LODHA PALAVA

Florea and Olivia Podium Retail Landscape

Florea Option 1A

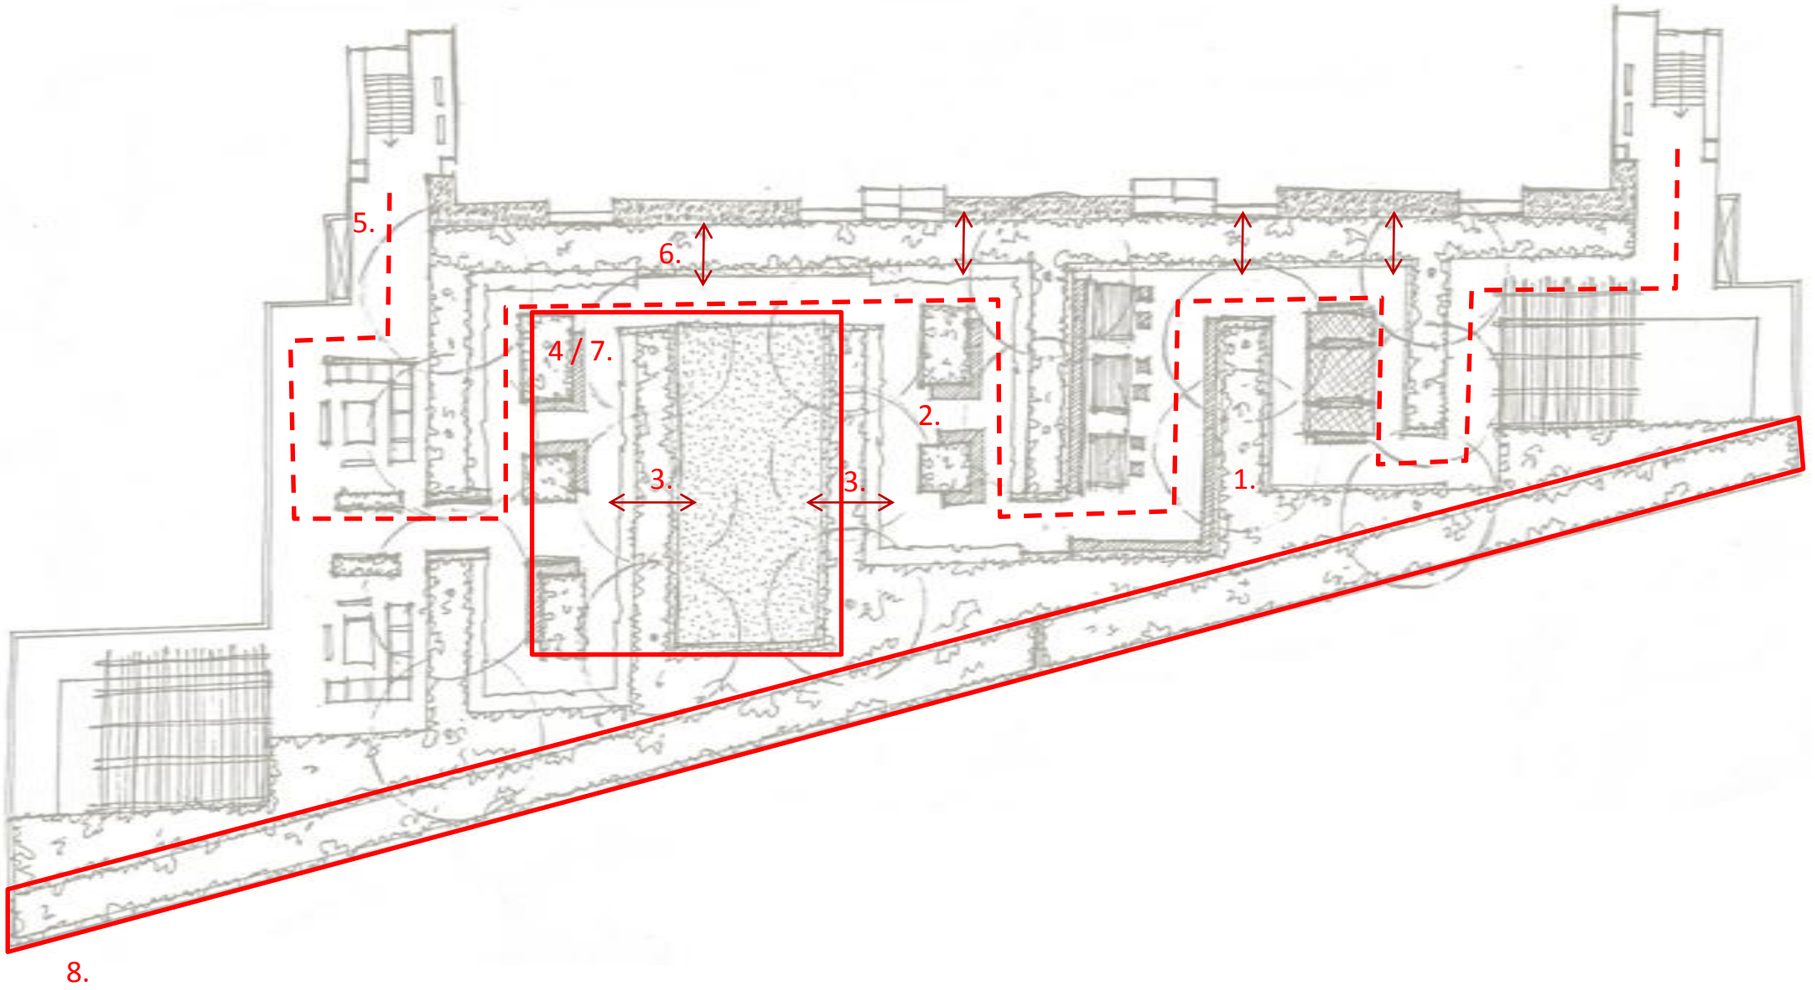
1. Trees possible only on the column grid - structural team.
2. Seating orientation towards the play area
3. Make kids play / lawn area accessible from other two sides
4. Single large lawn for the kids to free-play preferred .
5. A loop or direct walkway for the elderly to take a walk
6. Main movement line away from the units for better privacy.
7. Lawn + deck to be designed to felicitate small society function/party.
8. No planting on the service shaft

Florea_Option 1

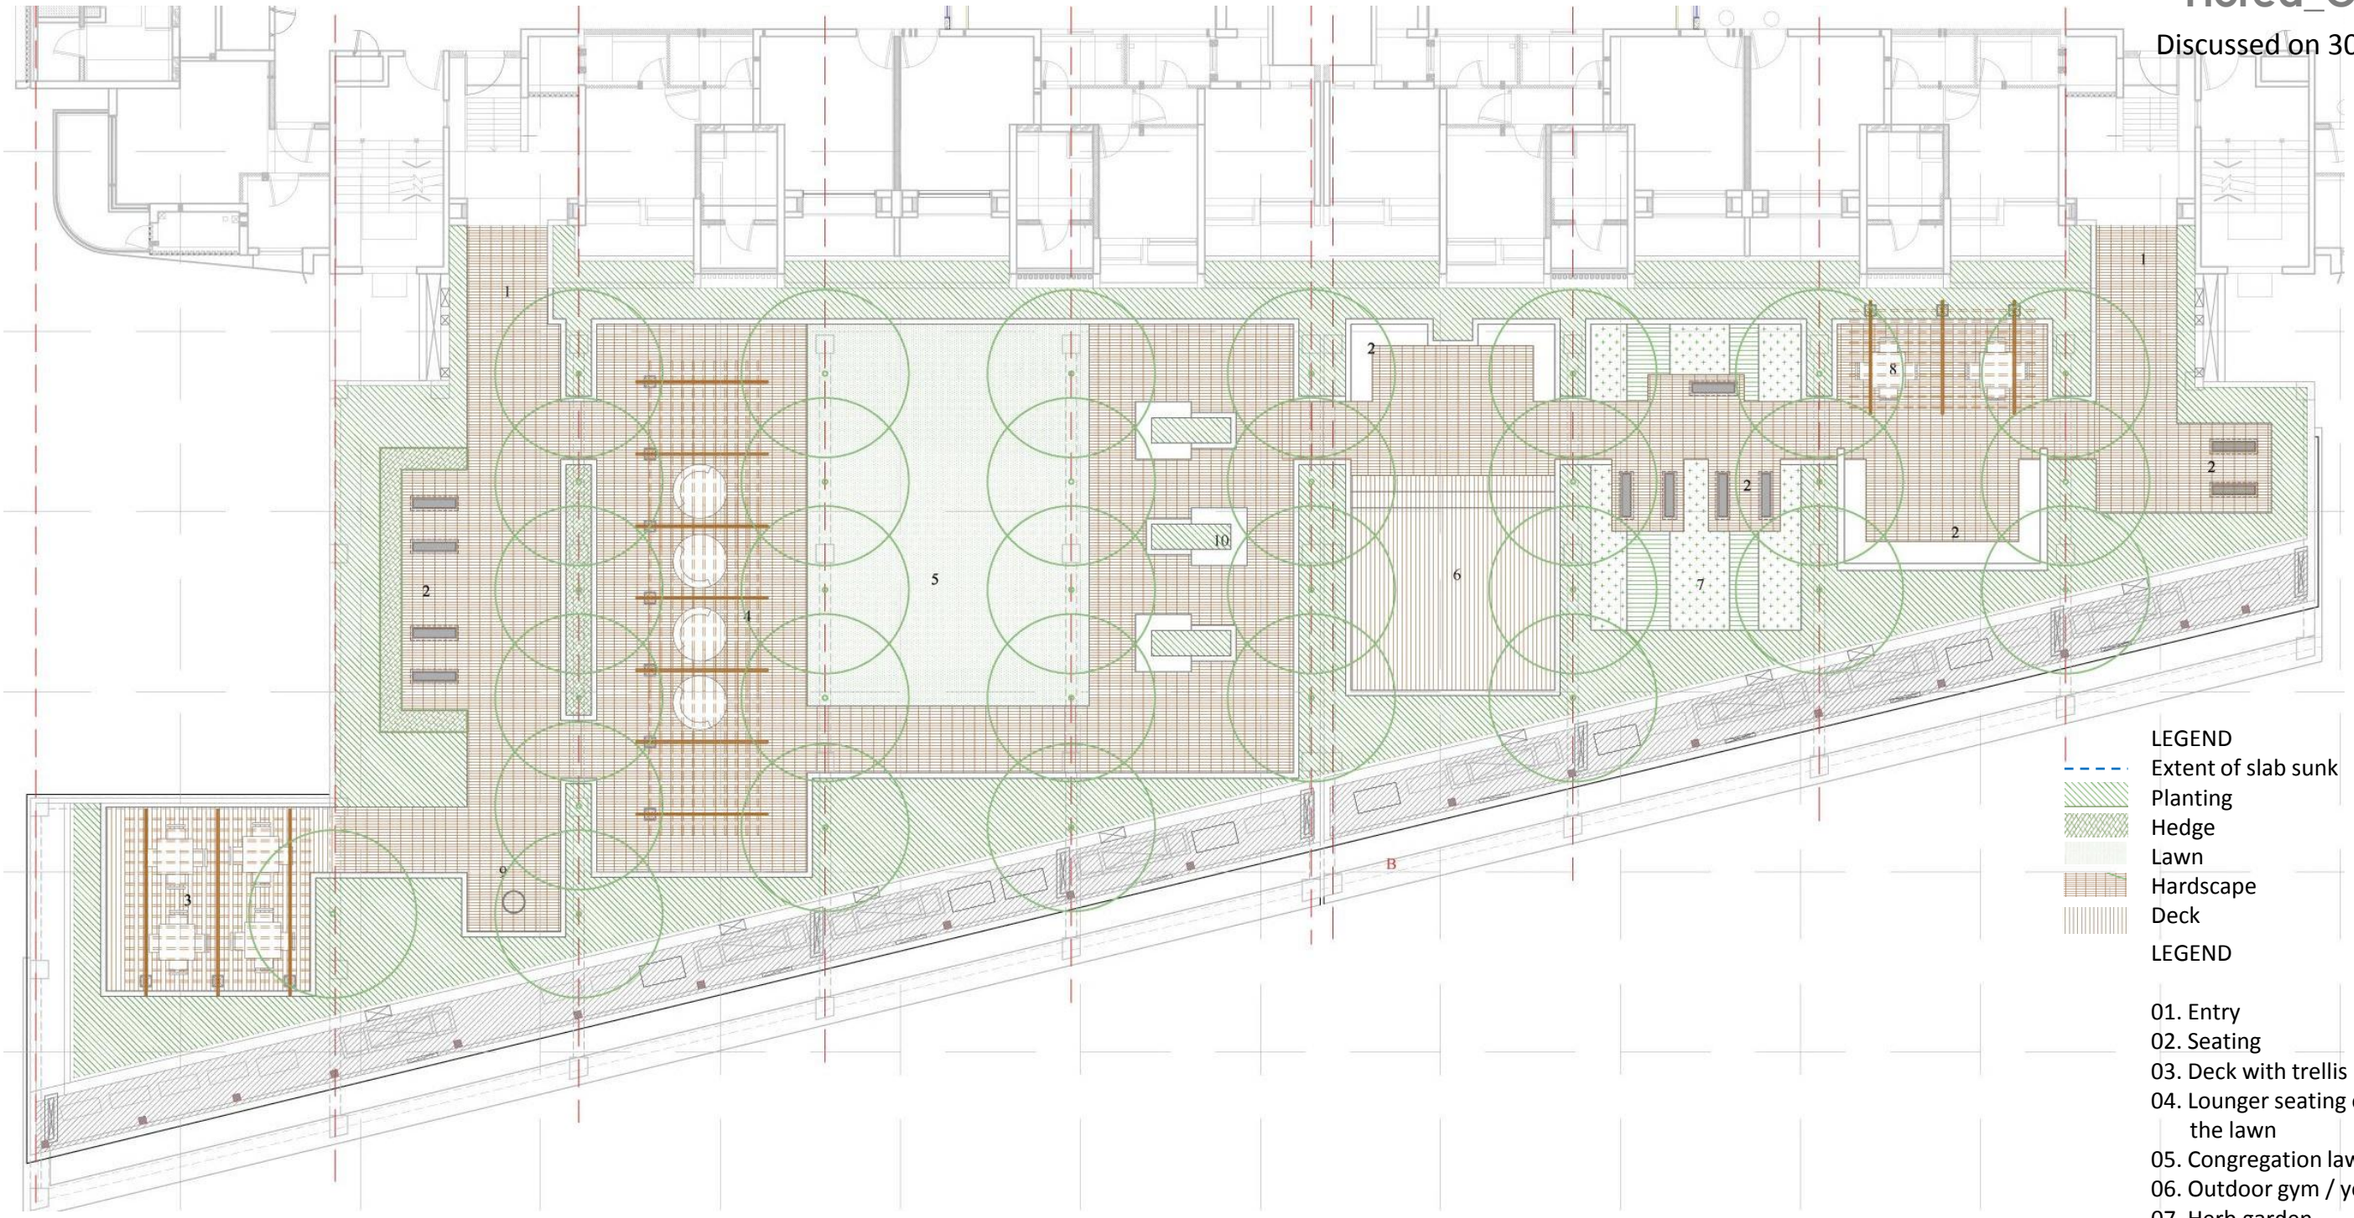
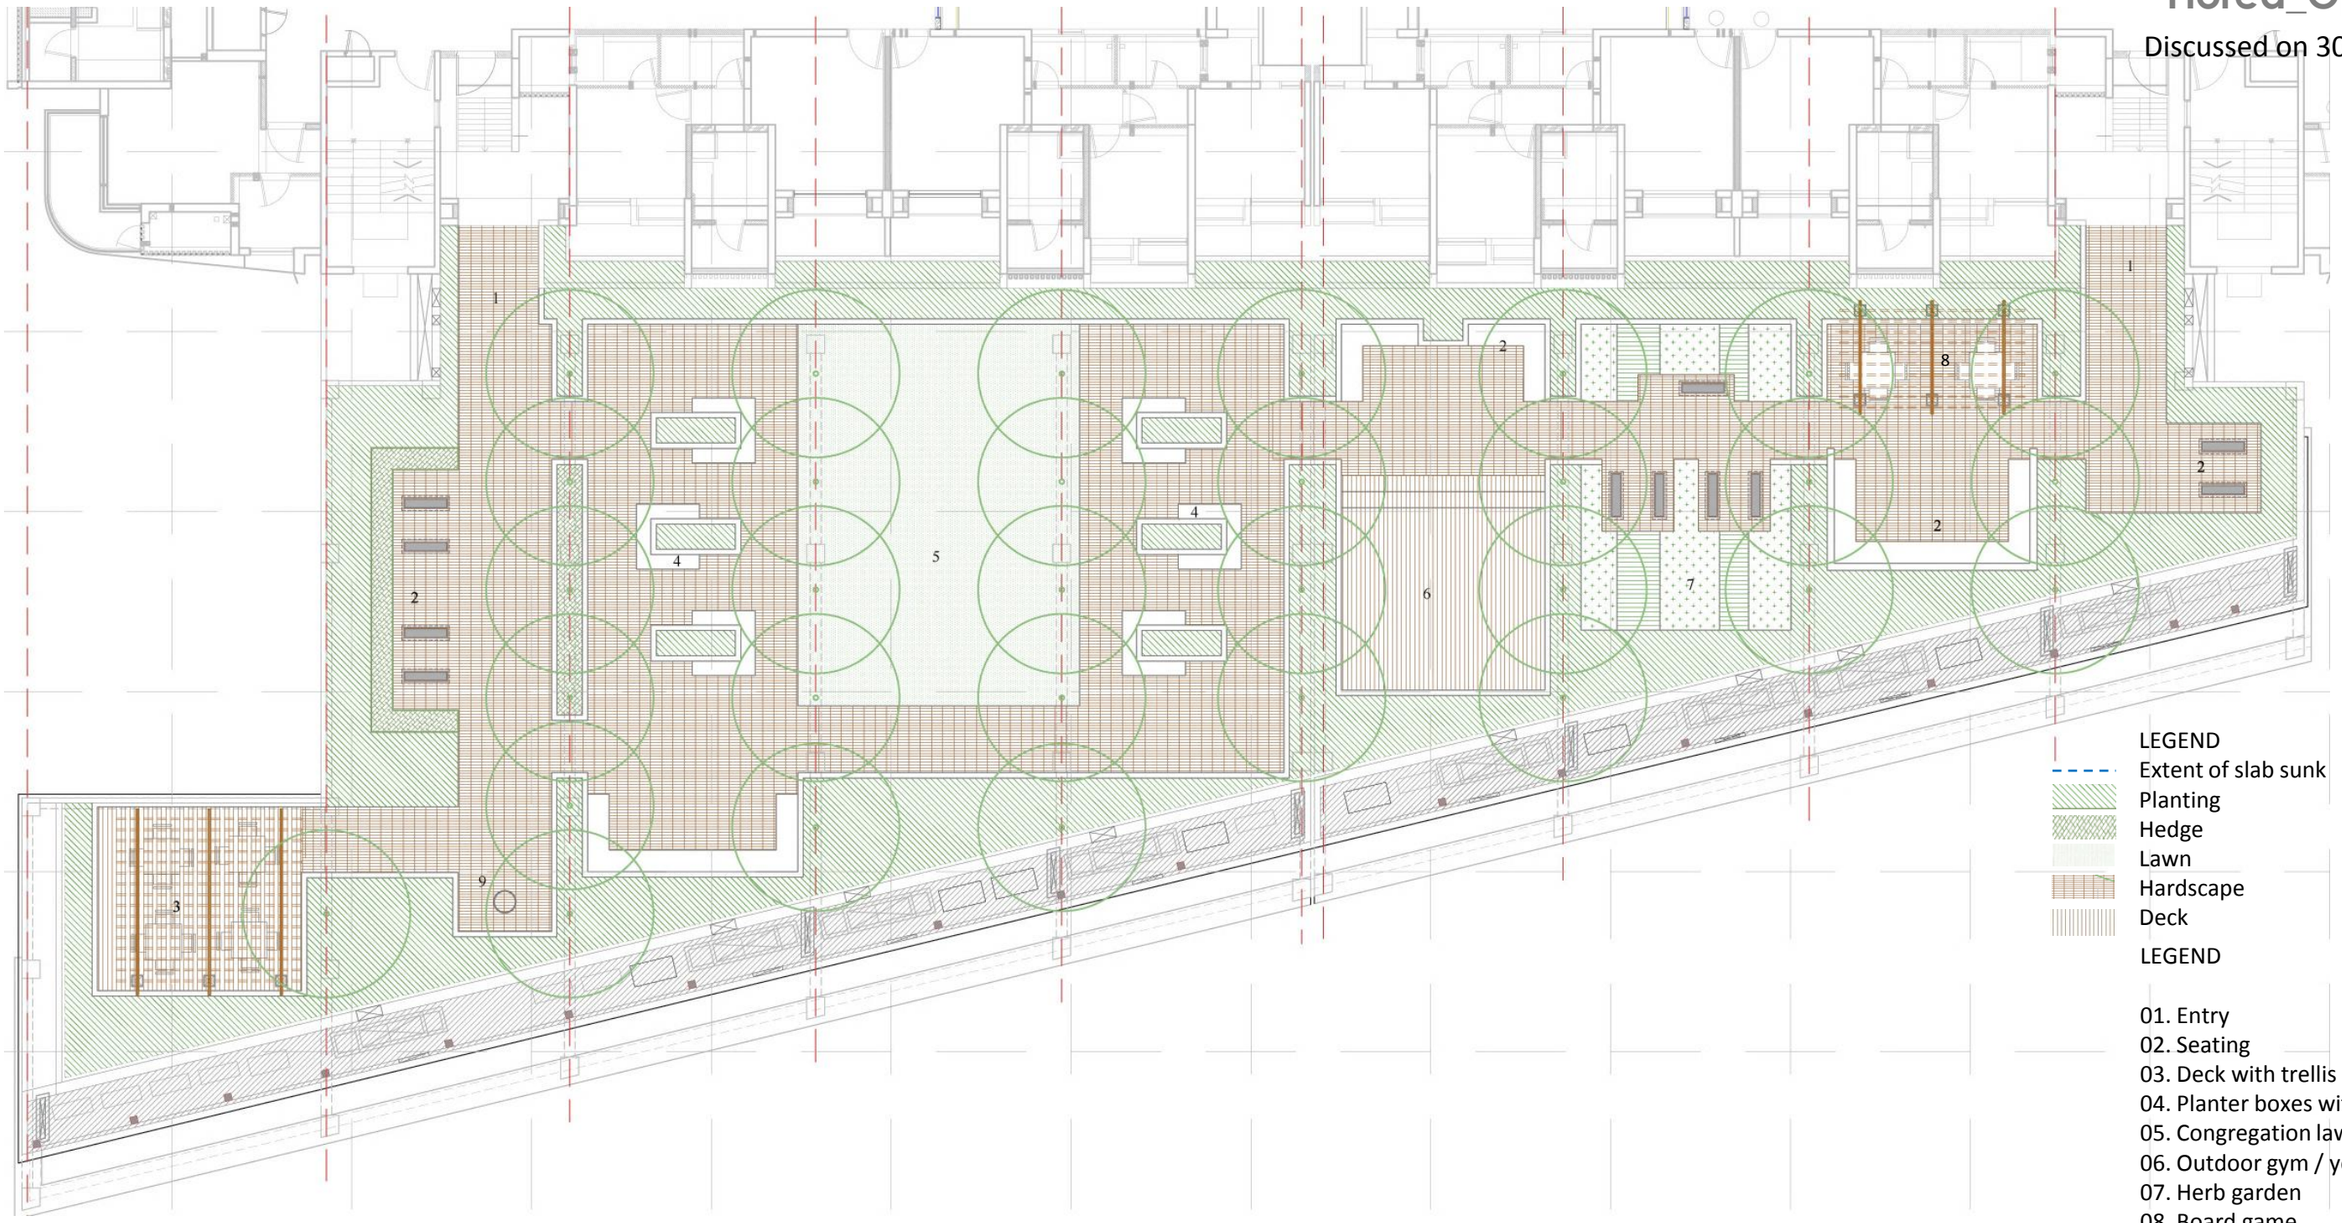
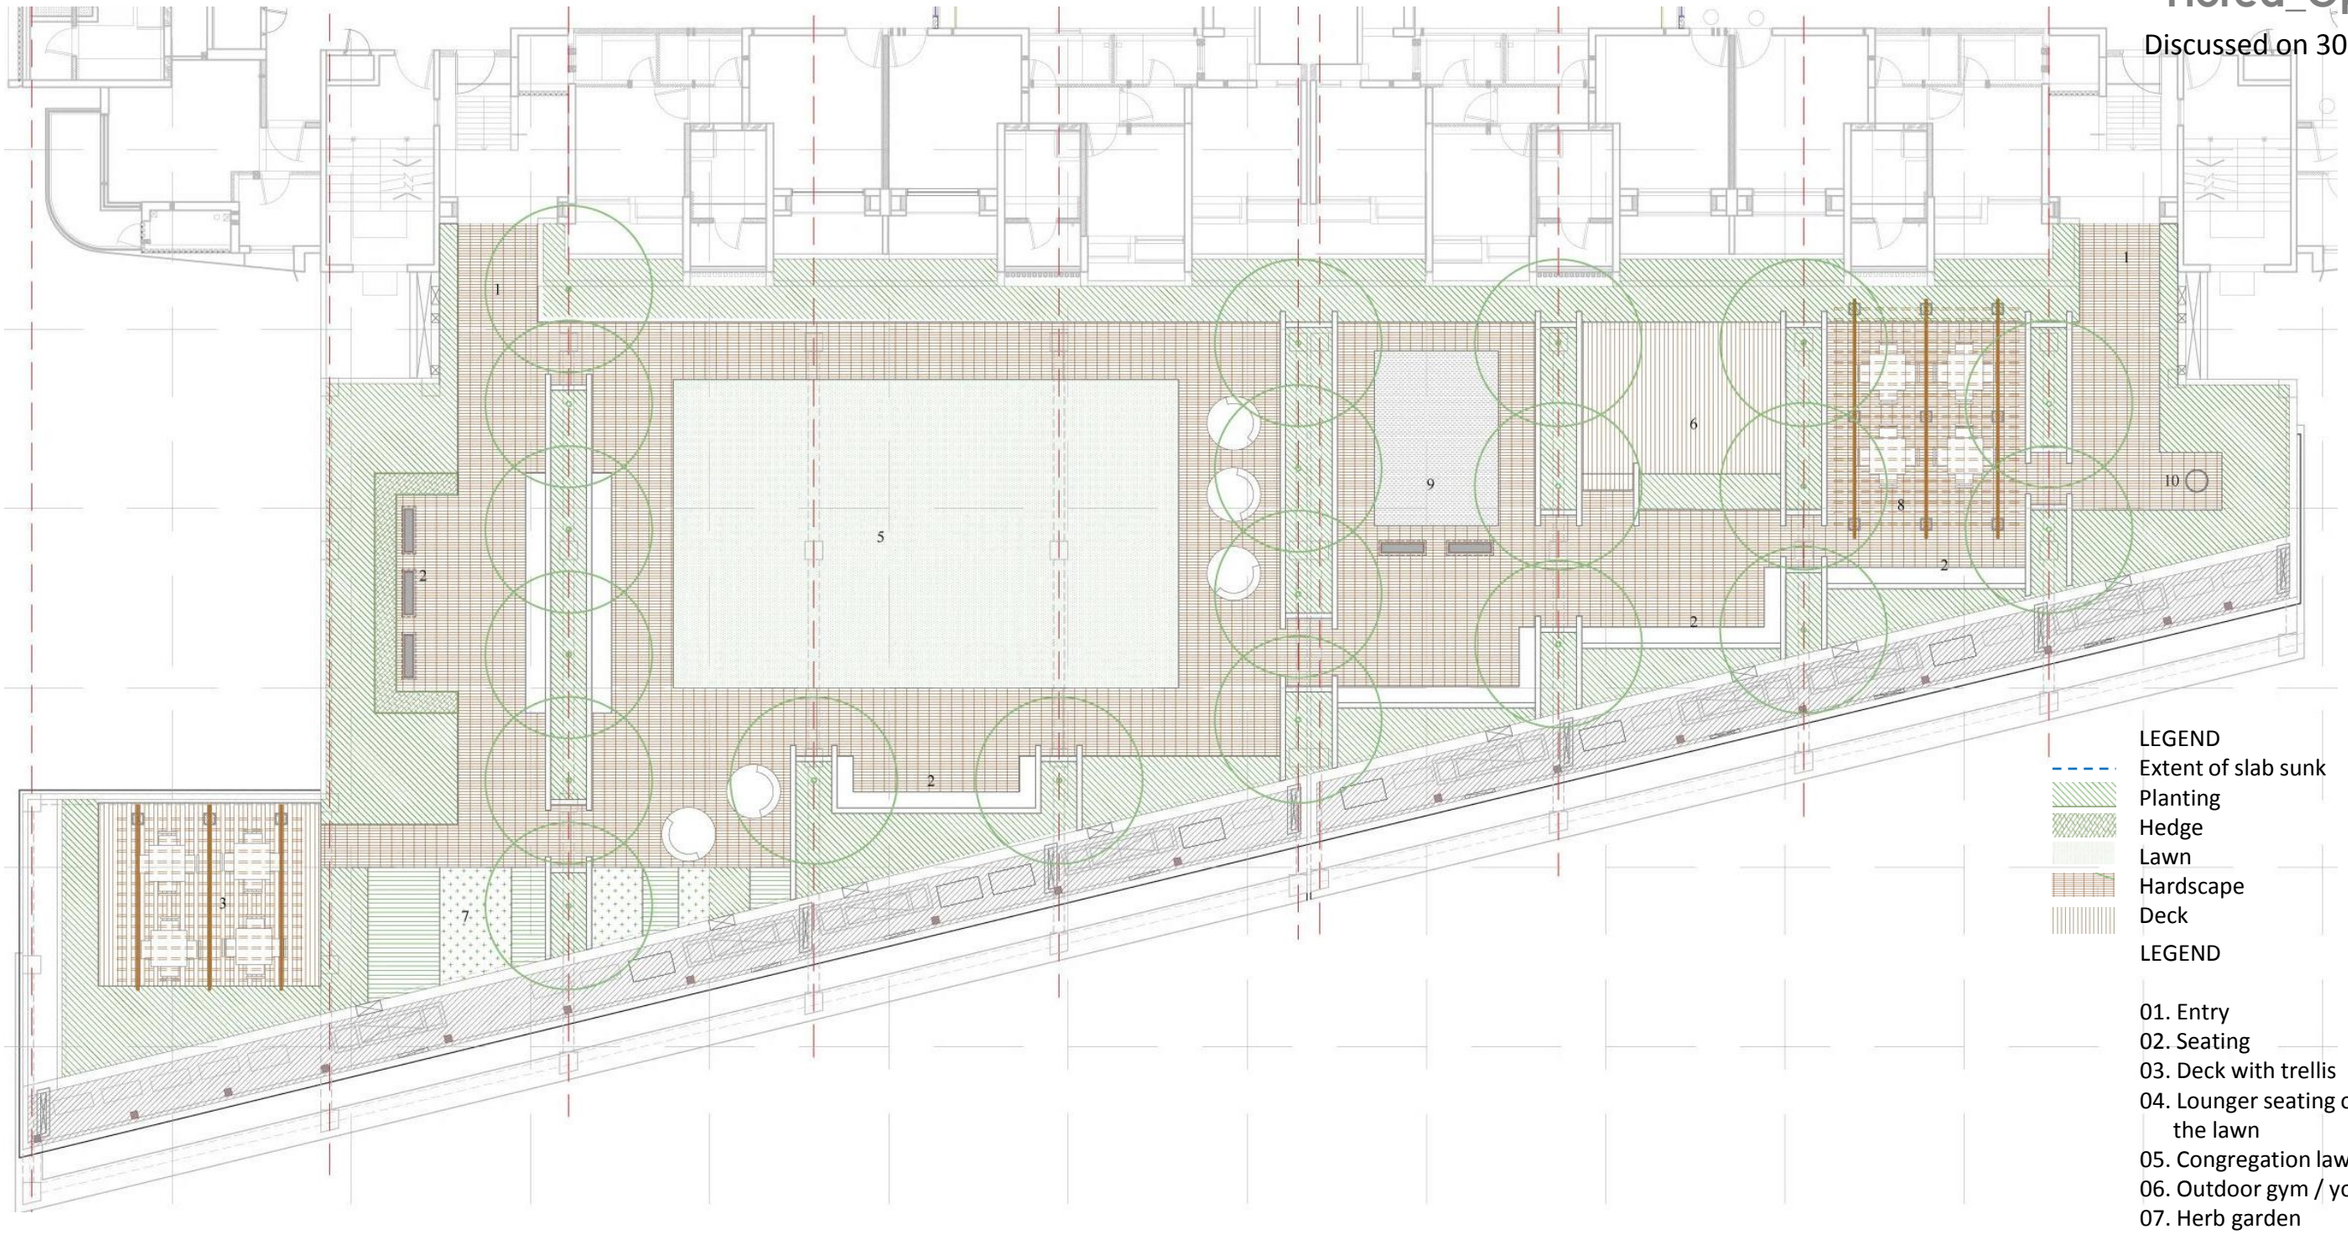
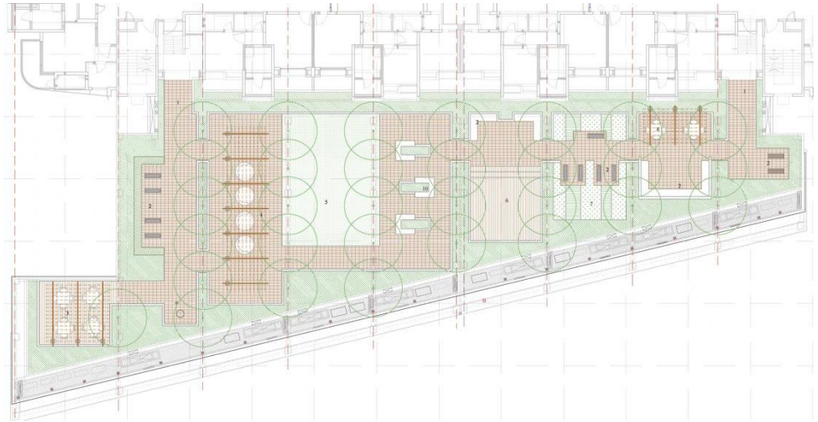
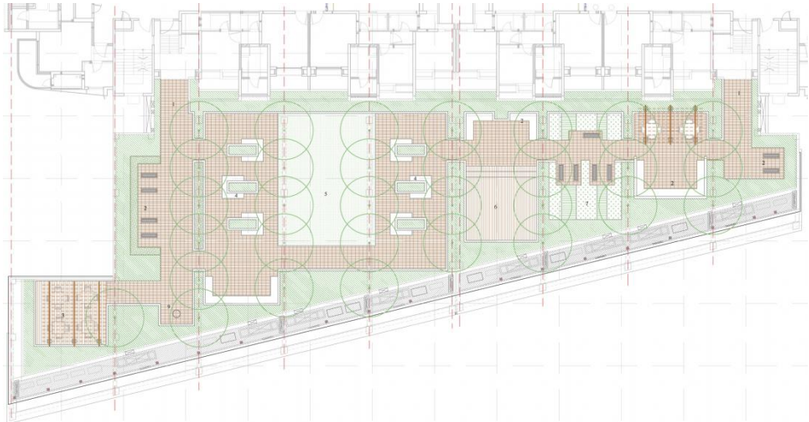
1. Requirement of a larger congregation lawn
2. Proposed trees need to be on the columns only and not on the column beam grid.
3. Group Activities should be proposed away from the apartments to avoid disturbance.
4. No vertical element like trellis / walls in front of the apartment windows .
5. Trellis deck with seating to be moved away from the parapet wall
6. No vertical elements in the 2mts sunk (service corridor)

- Large lawn size - Option 3 preferred
- Variety in seating arrangements and type - Option 1 preferred
- Semi covered spill out space for the congregation lawn - Option 1 preferred

Overall Option 1 is preferred with the lawn size as in option 3.
